TECHNICAL INFORMATION

TI0217

Machine type/s:

HO SIAMONIE

407.01.606.00 OUTFLOW PISTON COMPL.

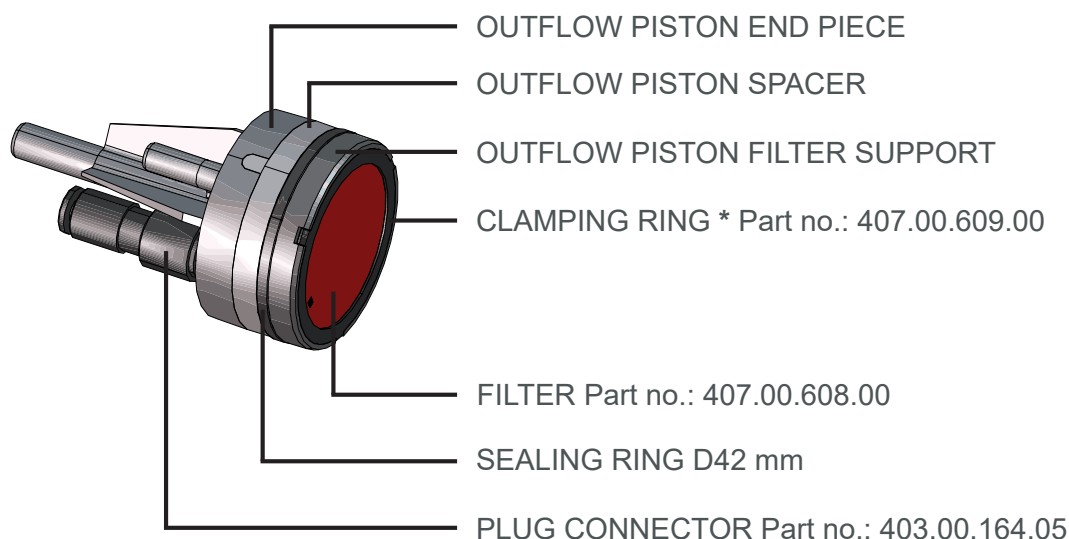
We would like to inform you that the material of the “outflow piston filter support” now includes glass fibre for improved rigidity.

The new part is recognisable by the colour (black instead of beige) and has been introduced in production from machine serial number 9044422, production date Week 04/2017.

The following plastic parts * are now black:
